BAR Meeting
September 22, 2010

ISSUE: Partial Demolition/Encapsulation and Additions/Alterations
APPLICANT: Michael Ann Casey (Case Design/Remodeling, Agent)
LOCATION: 918 ½ Pendleton Street
ZONE: RB / Residential

BAR CASE #2010-0018/0020

Figure 8: Proposed Left (East) Elevation

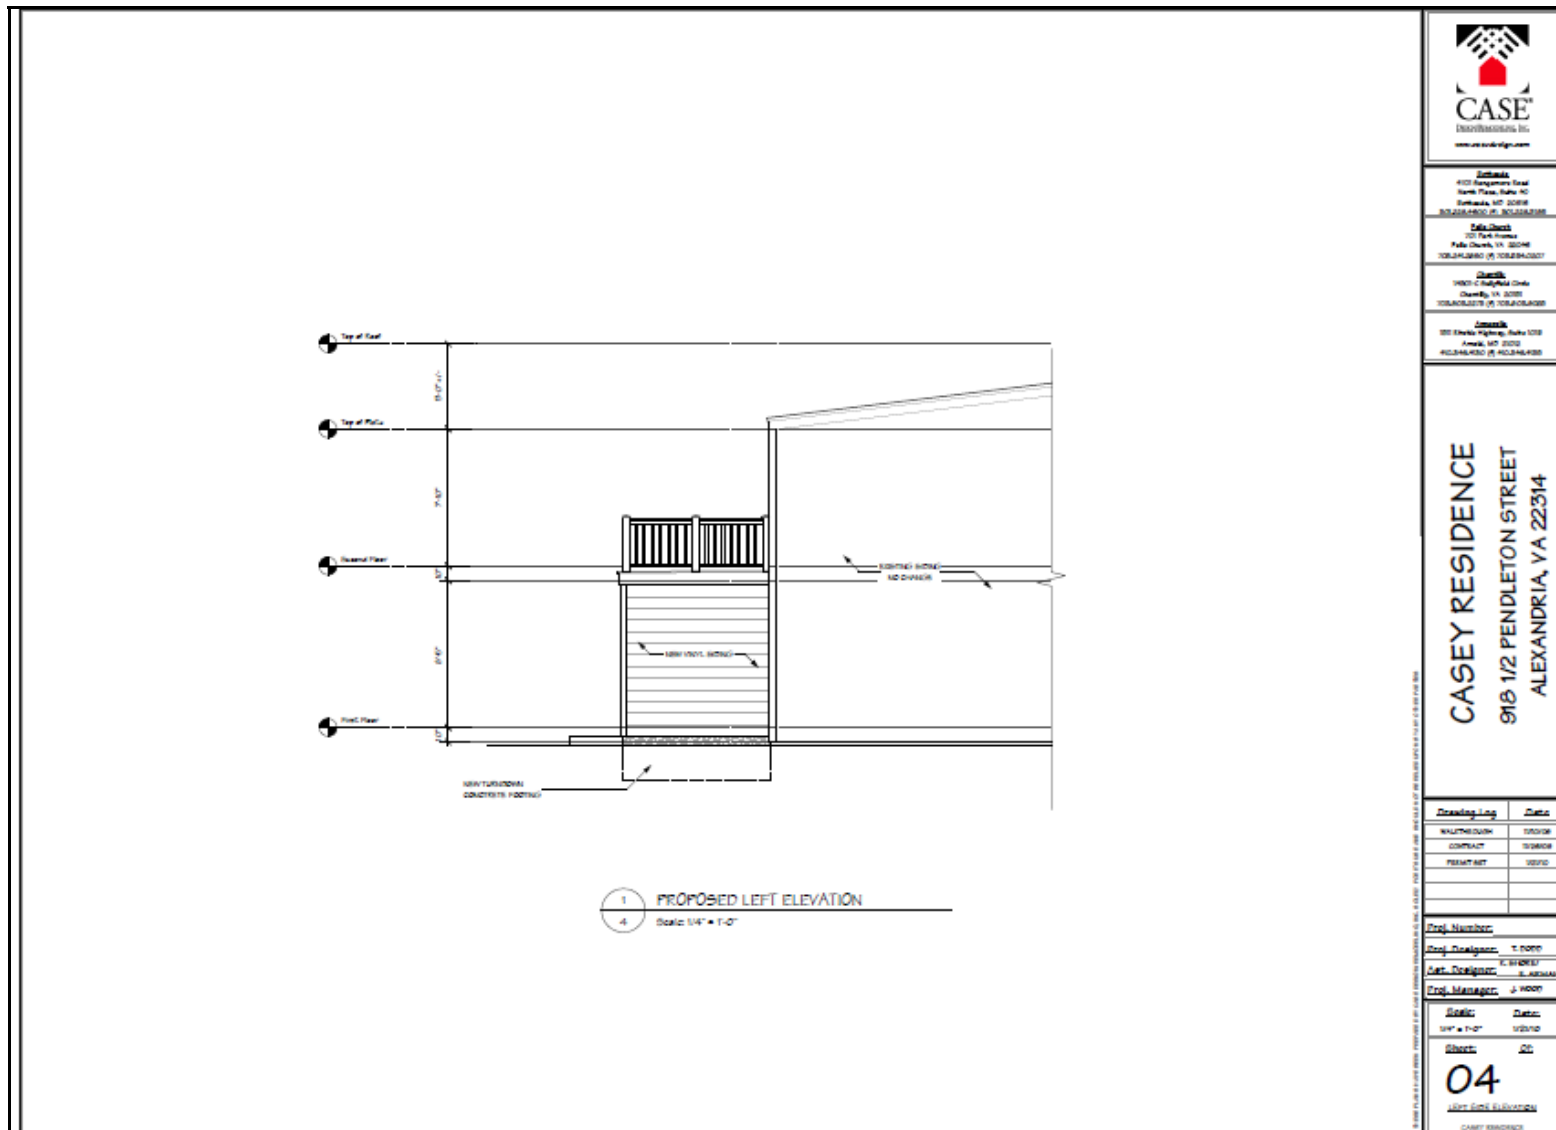
1. That the 6/6 aluminum clad wood windows on the additions are changed to 1/1 aluminum clad wood windows.
2. That the French door is changed from a multi-light door to a single-light French door.

3. That the six panel wood door is changed to a four-panel wood door.
4. That the wood siding is specified as German lap siding.
5. That all the trim including balustrades are fabricated out of wood or a paintable synthetic/composite, solid-through-the-core, high-quality material.

The proposed new additions are designed to accommodate a sunroom and a storage/mechanical room, as well as a larger bathroom on the second floor. The rear (south) elevation of the addition will be detailed with a single multi-light door, a six-panel door and a set of paired, six-over-six, double-glazed, double-hung windows on the first floor. The second story will have a single, six-over-six, double-glazed, double-hung window and a single multi-light door, which leads out onto the full-width balcony. Due to the close proximity of the additions to the property lines, the side elevations of the addition will have no fenestration. The new roof structure of the additions will intersect and extend the existing shed roof. The proposed materials include: aluminum clad wood windows, wood siding, modified bitumen roofing, a hollow, PVC balustrade.

The proposed addition’s massing and scale are compatible with the existing vernacular style of the house. The proposed second-story addition will extend the original house’s shed roof form. However, Staff recommends that the proposed wood beveled siding be German lap siding to be compatible with the existing wood siding and the Victorian style of the house.

In addition, the proposed doors and windows are a 6/6 window, multi-light French door, and 6 panel wood door. These details are Colonial Revival and Staff would recommend that a more appropriate Victorian period style be utilized. This would include a 1/1 window (to match the existing windows on the front), a single light French door and a 4 panel wood door. Although the *Design Guidelines* state that “single glazed true divided light wood windows” are the preferred window type, Staff notes that the Board has regularly approved double-glazed windows on new construction, and staff supports that here to reduce energy consumption and increase occupant comfort. Staff further believes the proposed aluminum-clad windows are appropriate for a new addition where they are minimally visible to the public. Aluminum clad windows are among the most expensive, highest quality and most durable windows available on the market and have been approved by the Board several times in the past.

Furthermore, the current proposal specifies that the balustrade is fabricated of a pressure treated post with PVC sleeve and, we believe, hollow PVC balusters. The Board generally considers high-quality synthetic/composite materials to be solid-through-the-core, paintable, milled similarly to wood, and to have a similar texture and feel to solid wood. Therefore, Staff finds the proposed use of the pressure treated post with PVC sleeve not consistent with these policies and recommends that the applicant submit either a painted wood balustrade or a balustrade fabricated from a high-quality synthetic/composite solid-through-the-core, paintable material to be approved by Staff with their building permit. Finally, the drawings indicate a corner board being utilized at the junction point between new addition and the original structure. This treatment is sufficient to distinguish the addition from the original structure for this simple vernacular dwelling.
